Adequacy Review Letter M2023004

Blattner Energy, LLC
 Bronco Plains II West Pit
 Map Exhibit E-1 Mining Plan
 Prepared on 3/31/2023

Blattner Energy, LLC
 Bronco Plains II West Pit
 Map Exhibit E-2 Reclamation Plan Map
 Prepared on 3/31/2023

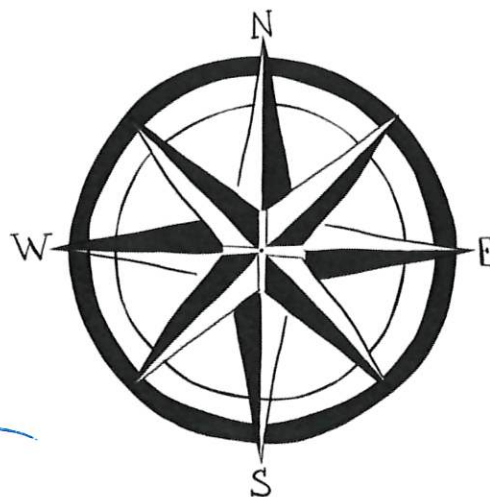
19.) Please see attached "EXHIBIT E 1" "EXHIBIT E 2".

The boarder of the image is 200 Feet or more from the Pit boarder. The only land owner of the afected property or 200 Feet away is "Robert C. Bledsoe Trust and Catherine L. Bledsoe Trust"

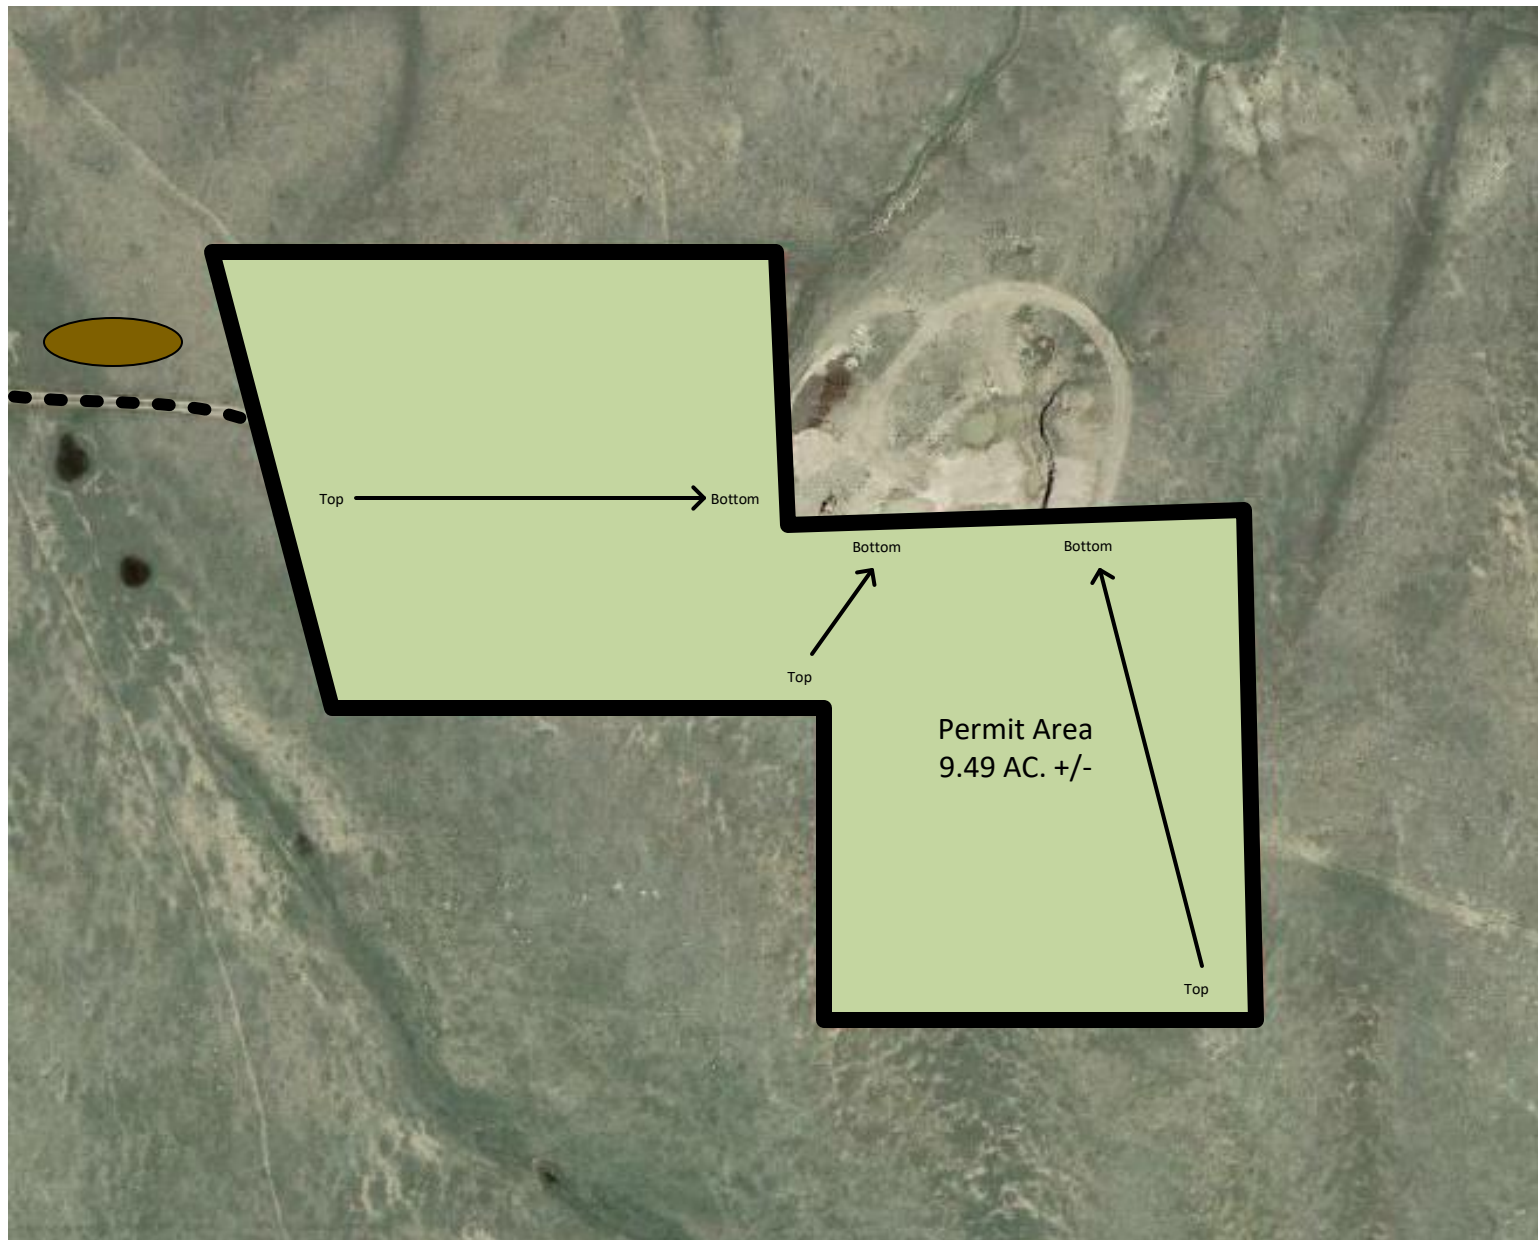
20.) Please see attached "EXHIBIT E 2".

21.) There will be no overburden material to replace. Please see attached "EXHIBIT E 2".

We will be replacing the topsoil over the entire pit returning the land to Range Land. The plan is to slope the grade at a 4:1 towered the previously mined area. There will be a small amount or gravel left behind for the land owner per there request. There will be no shrub or trees planted. We are expecting 6-12" of topsoil. There will be no overburden material to replace.
